From: NDavies@GeoSyntec.com
Sent: Friday, March 03, 2006 4:58 PM
To: Julian, Hank
Cc: TElkady@GeoSyntec.com; Petty, Harold L.
Subject: RE: KIF Peninsula: Draft EA

We have reviewed Section 3.2.2 as requested. I will send you by separate email a pdf of a couple of pages where we have revised and/or questioned a few of the specific numbers in the test related primarily to areas/volumes etc. The revised numbers are from the current version of the design drawings.

Installation of Flue Gas Desulfurization
System at Kingston Fossil Plant

Figure 3-1. Plan View of Site at Proposed Final Grade Including Cross-Section Location A

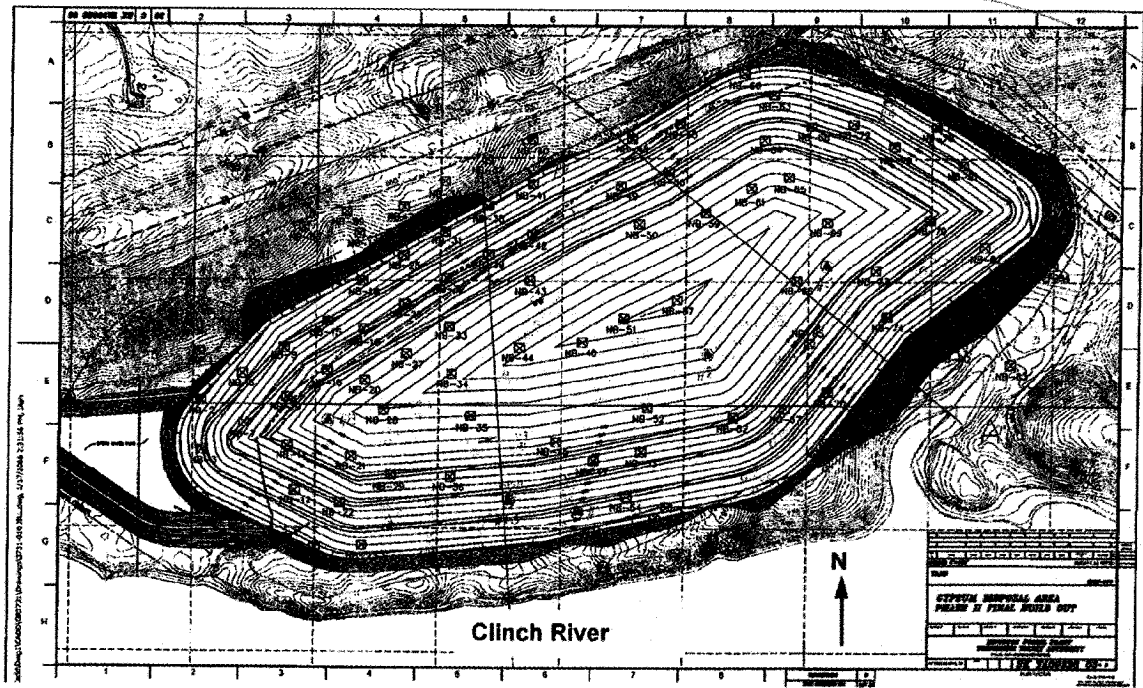
57.4 92.7

5 # coal has been used in design.

We have a revised figure if you would like it

Figure 3-2. Typical Cross-Section Geometry for End of Dry Stack Operation

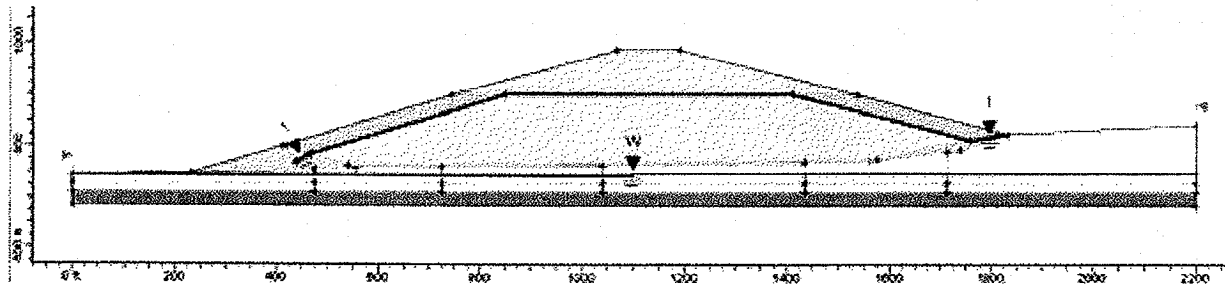
What does this 32 in chert 2006 recent geotechnical borings?

? - quantities differ to those used in the PPD
